GENERAL APPLICATION

Location Address: 1735-1739 Jackson Street

SUBJECT: Preliminary Site Plan review for a 78 Unit residential development.

4 PROPOSED SITE PLAN

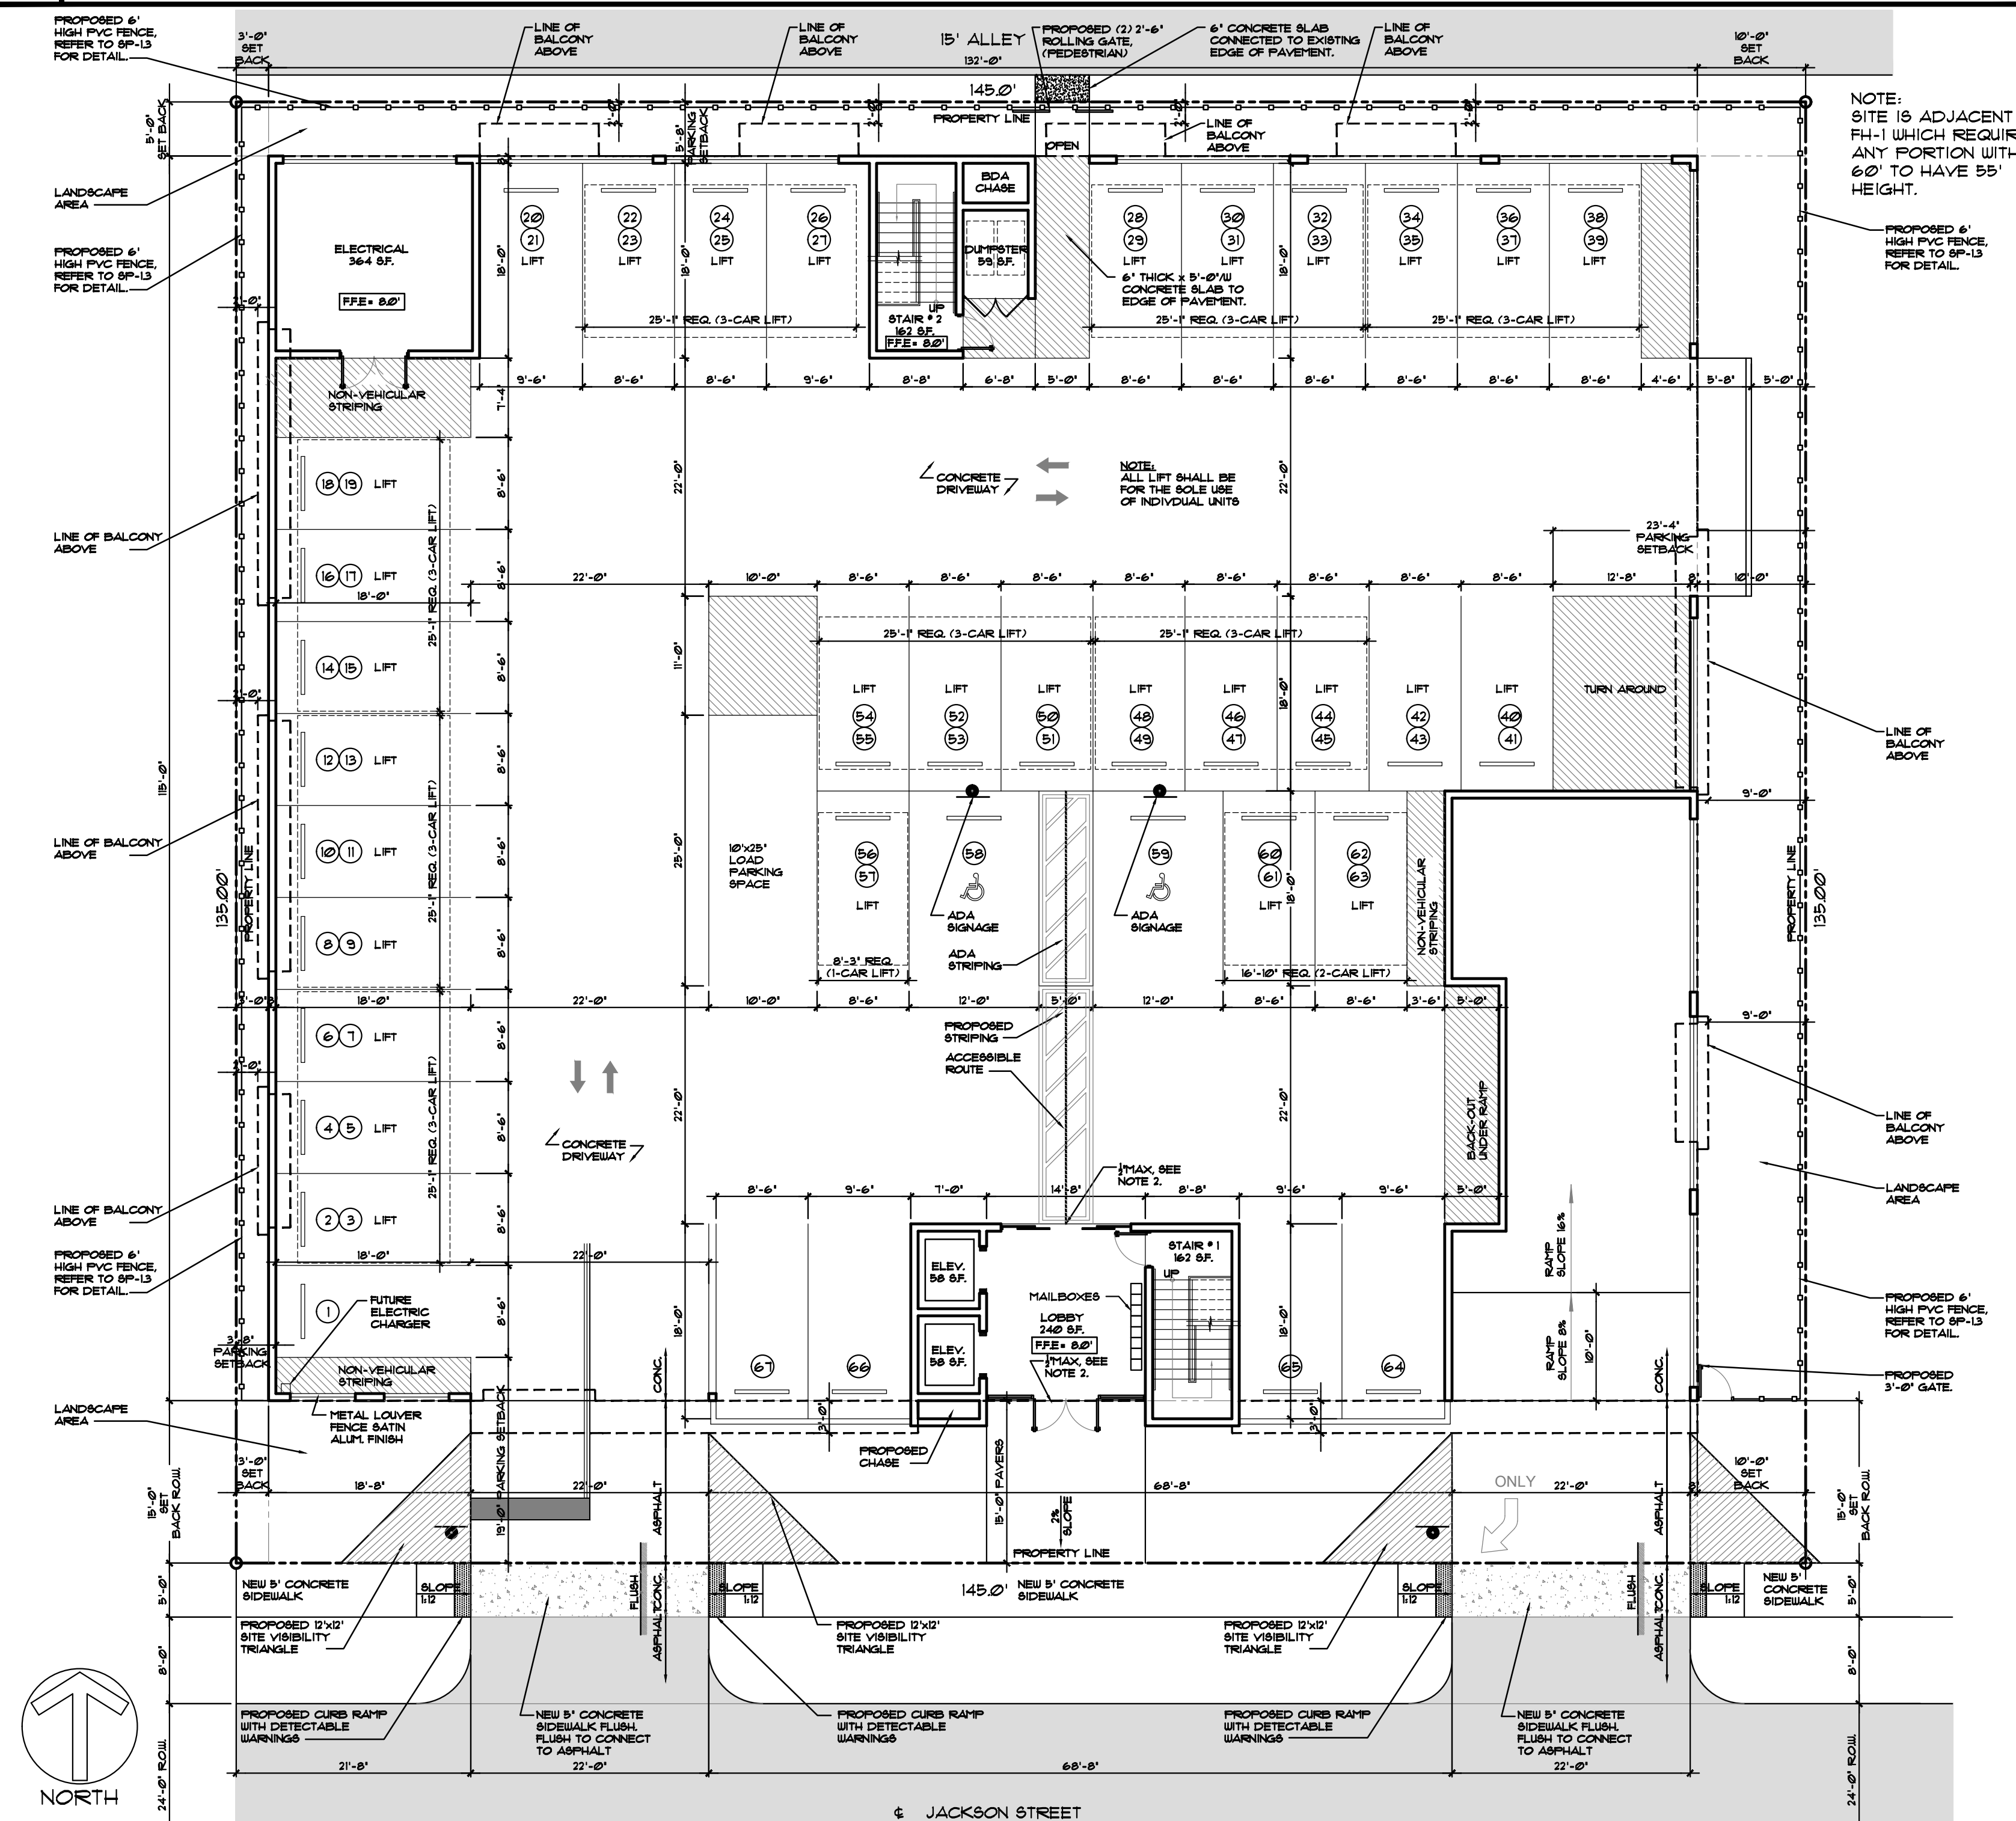
2. Site Plan:
 - a. Use a heavier line weight and label the building location. As submitted, it is difficult to determine where the footprint of the building is shown on the site plan.

- g. Detail 5 references a “game room” on the second floor. This is not identified on the floor plan.

- h. Specify the purpose of Detail 6 on the plan. It is unclear what this detail is referencing.

- f. Notes 3 states a detail for the car lift is included on site plan sheet 2. No detail could be located on that plan sheet.

5. Add a note to the site plan that the parking lift system shall not be for the use of guests.

13. The site triangle on the east side of the easternmost driveway encroaches on adjacent property. Revise location so the site triangle is located wholly on the subject property.

Response: Revised Accordingly
 - b. The front setback dimensions of the site plan and site data shall be revised match.
Response: Revised Accordingly, refer to SP-1.1

Response: Revised Accordingly, refer to SP-1.1
 - d. Identify and label all landscaped areas.
Response: Revised Accordingly, refer to SP-1.1
 - e. Identify the proposed bike storage location.

Response: Revised Accordingly, No game room, refer to SP-1.1 & A-1.2 showing mangers office on 2nd. Floor and fitness center on roof.

Response: Detail was removed it did not apply.

Response: Detail is provided in Spec sheet as per mote 3.

Response: Note 5 on SP-1.1 states that lifts are designated for each 2-bedroom unit.

Response: Refer to SP-1.2

PROPOSED TYPICAL 6TH FLOOR PLAN

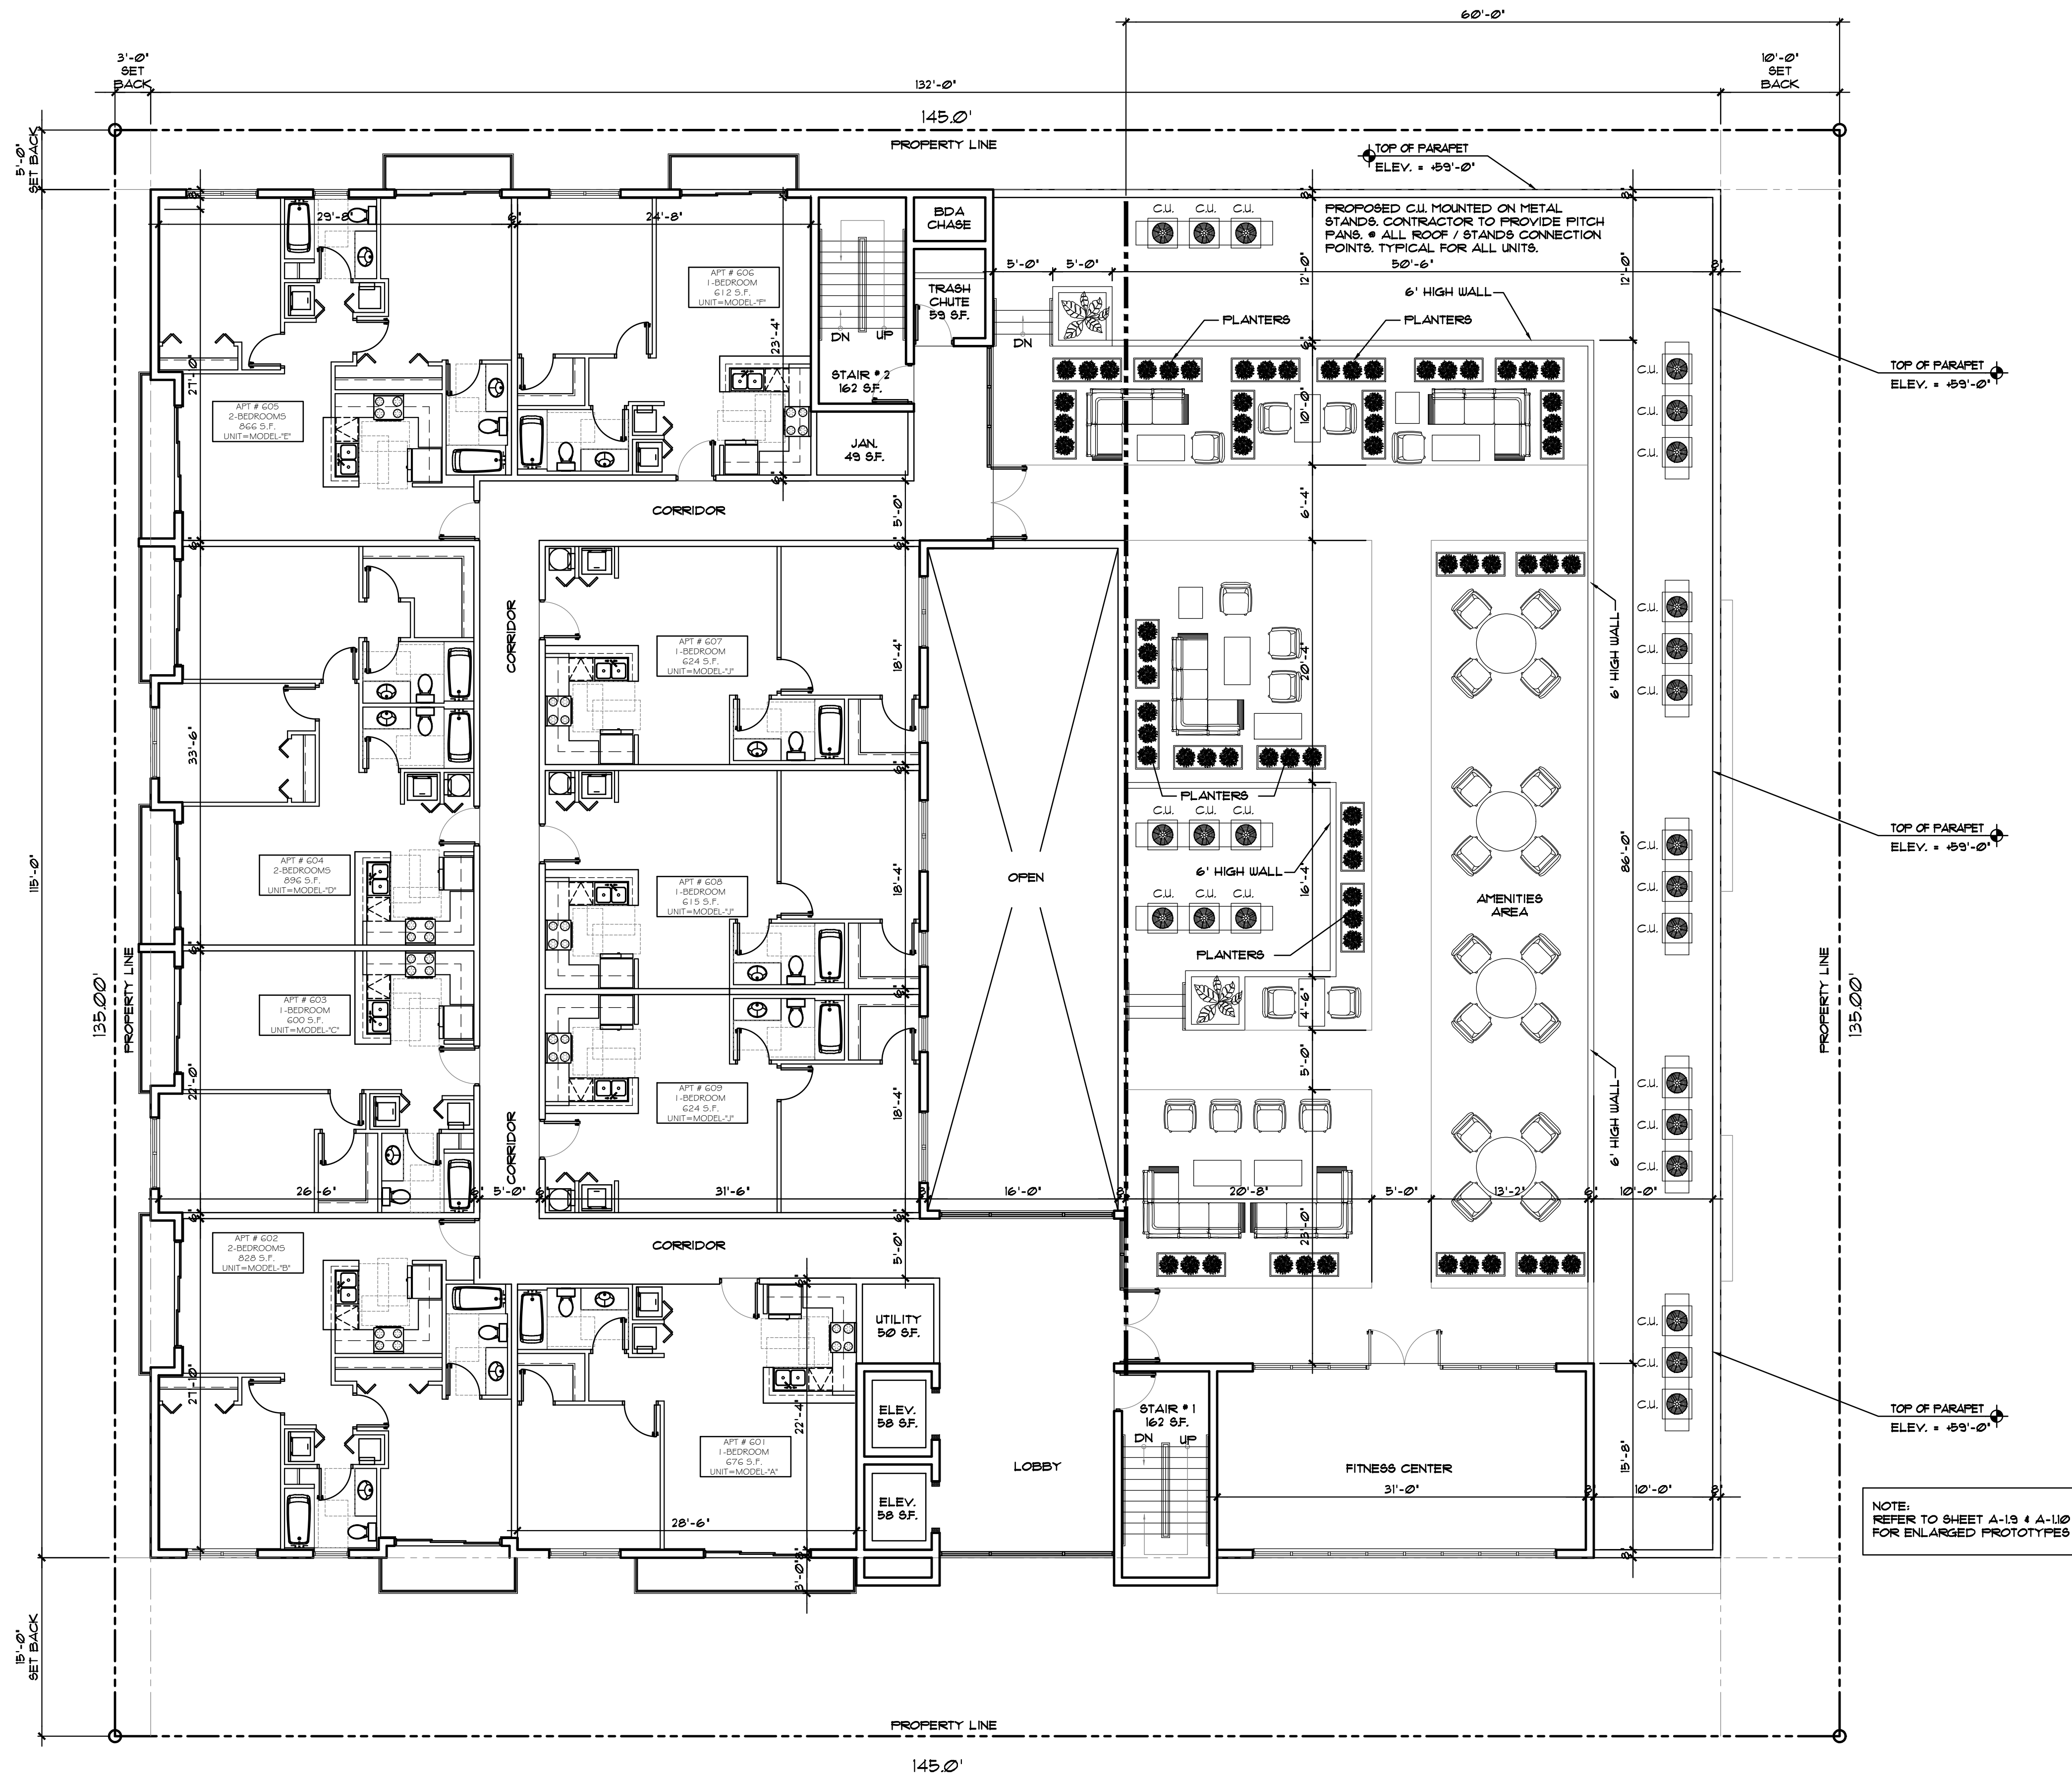
1. A portion of the property is adjacent to property zoned FH-1. Graphically depict on the site plan, floor plan and elevations the portion of the property within 60 feet of property zoned FH-1.

- b. Per the FH-2 District Development Regulations, development above 55 feet in height shall provide a minimum 60 ft setback to the side interior boundary.

- c. Based on the submitted site plan, floor plan and elevations, it appears that part of the building encroaches in the required setback and maximum height limitations for development adjacent to FH-1. The design of the building may need to be amended to comply.

7. Provide more details on the floor plan for the proposed 6th floor amenities area, including how it will be accessed.

Response: Refer to sheet A-1.6 96th floor plan) showing 60' setback requirements. Note, that only portion encroaching into 60' height setback is stair and Fitness center which are allowed to exceed height but not past 25%

Response: Refer to sheet A-1.6 96th floor plan) showing 60' setback requirements. Note, that only portion encroaching into 60' height setback is stair and Fitness center which are allowed to exceed height but not past 25%

Response: Refer to sheet A-1.6 96th floor plan) showing 60' setback requirements. Note, that only portion encroaching into 60' height setback is stair and Fitness center which are allowed to exceed height but not past 25%

Response: Revised Accordingly
